## Product / Process Change Notification (PCN)

**PCN #:** PCN\_UtSTST\_20200914  
**Affected Series:** WE-STST; P/N 7493XXXX

**PCN Date:** August 13, 2020  
**Effective Date:** September 14, 2020

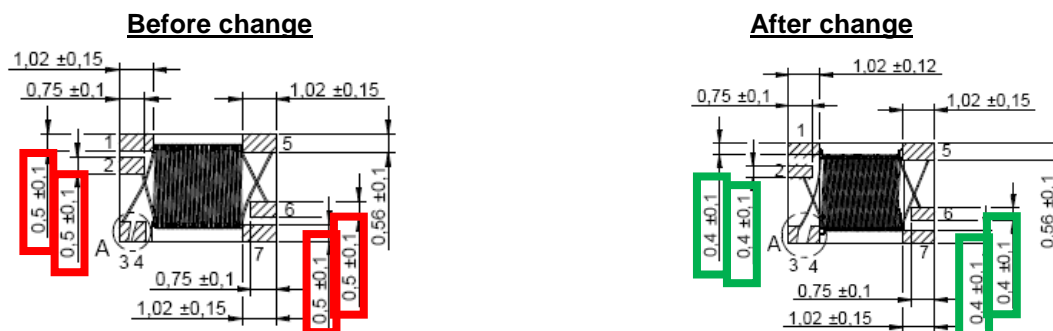
Due to a database mismatch, the width of the pads will be updated for part numbers 74930000, 74930100, 74930030, 74930120 and 74930130.

Pads 1, 2, 6 and 7 will be updated from 0,5 mm to 0,4 mm.
